COLLINS RADIO COMPANY

SERVICE BULLETIN NO. 1

EQUIPMENT TYPE: 32S-3 TRANSMITTER

SUBJECT: IMPROVE VOX CIRCUIT TO ELIMINATE INTERMITTENT DROPOUT, AND IMPROVE OPERATION OF FIRST AUDIO AMPLIFIER

32S-3 Chassis, Partial View Showing Location of Components Affected by This Modification

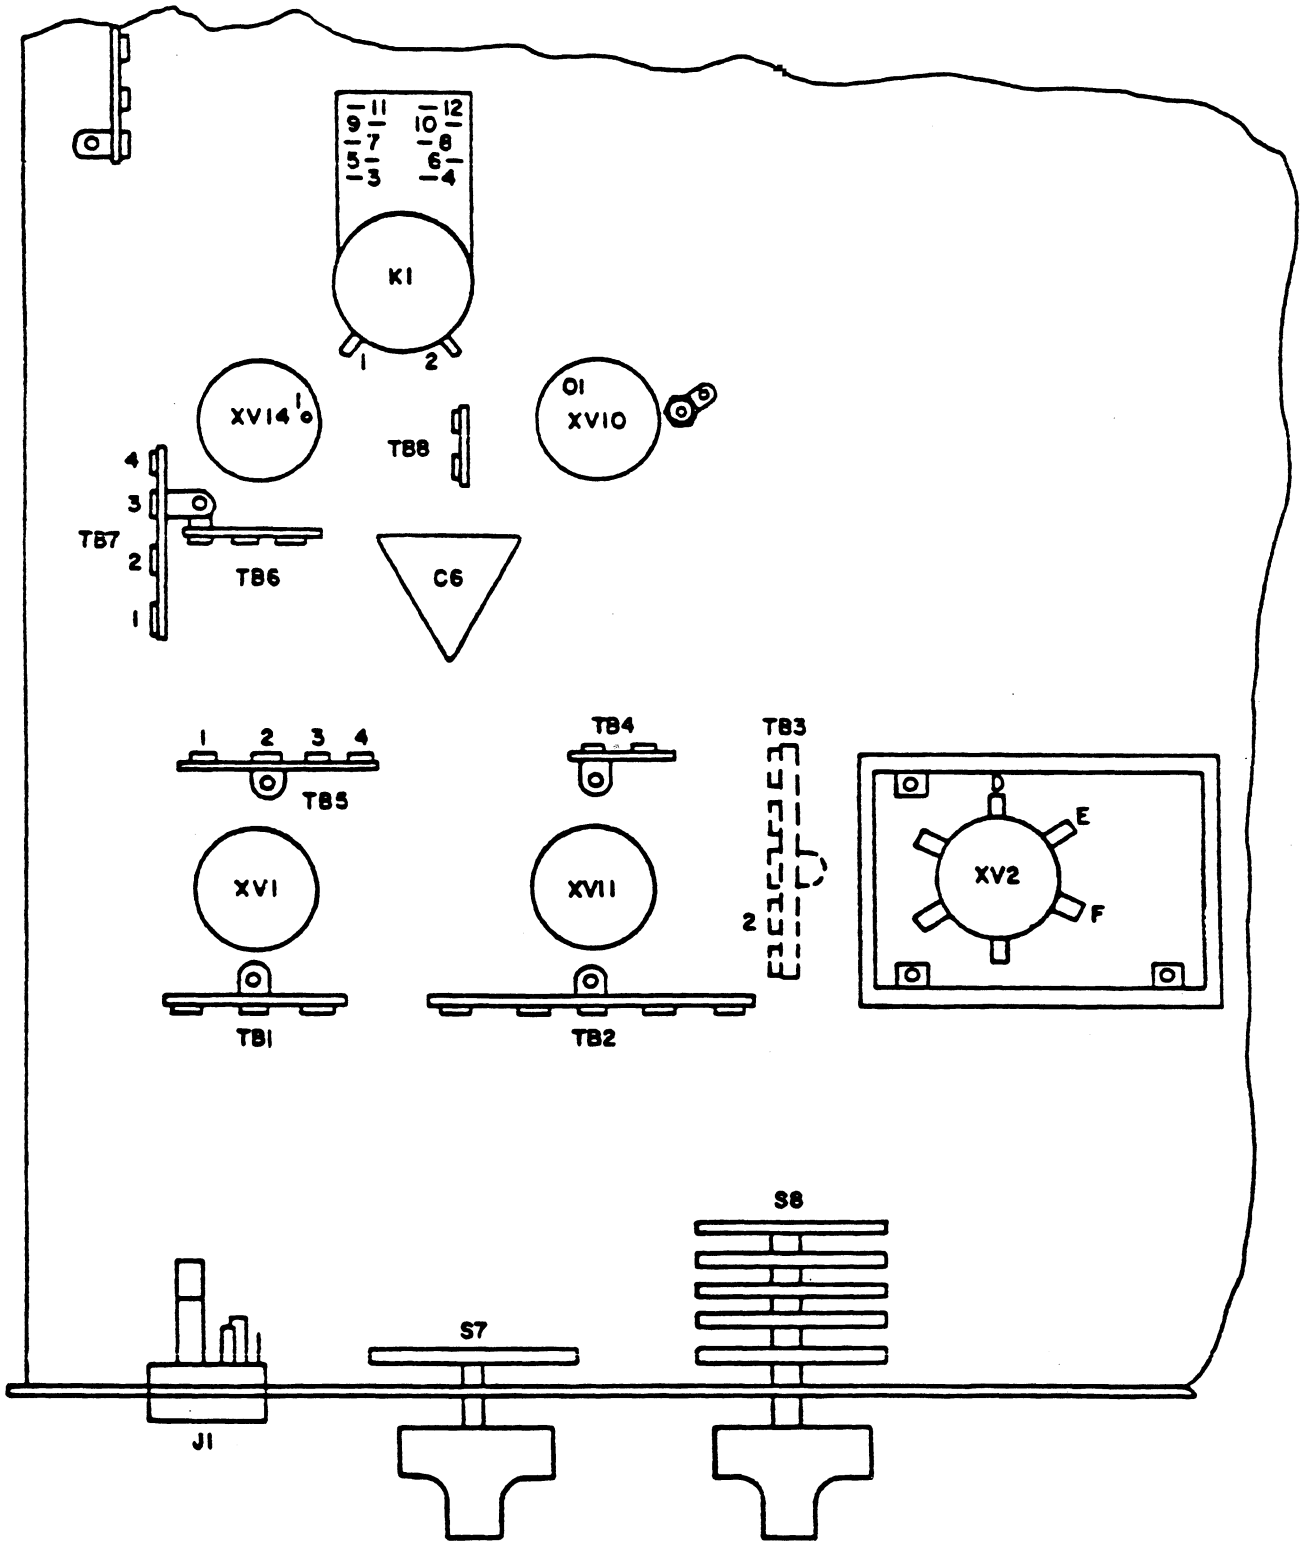
2. Substitute new 47K resistor R138 (745-1422-000) for choke L1. The choke is connected between tube socket XV1, pin 9, and terminal strip TB1.
3. Substitute new 100K resistor R101 (745-1436-000) for 1-megohm resistor R101. This resistor is located on terminal strip TB1.

4. Connect new 0.1-uf capacitor C188 (913-3152-000) between XV1, pin 8, and the ground terminal of terminal strip TB5.
5. Substitute new 0.02-uf capacitor C119 (913-2142-000) for 0.1-uf capacitor C119. Capacitor C119 is located between tube socket XV10, pin 5, and terminal 11 of relay K1.

6. Connect two new 0.1-uf capacitors C186 and C190 (both 913-3152-000) in parallel between XV10 pins 5 and 7.
7. Connect new 20-uf capacitor C184 (183-1165-000) between XV14, pin 8 (positive lead), and TB7, terminal 3 (negative lead).

8. Connect new 20-uf capacitor C185 (183-1165-000) between XV14, pin 3 (positive lead), and TB5, terminal 2 (negative lead).
9. Substitute a new 220K resistor (745-1450-000) for 680K resistor R73. Resistor R73 is connected between XV2, pin 9, and TB3, terminal 2. Transmitters that have a shield around XV2 do not have a terminal board TB3, and R73 is connected

between XV2, pin 9, and XV2, terminal F. To remove the shield, disconnect the choke L2 lead from XV2, terminal E, and the capacitor C92 lead from XV2, terminal D. Remove the three screws that secure the shield in place. These screws are removed from the top of the chassis. After R73 has been replaced, reconnect the component leads to the original terminals, and replace the shield.
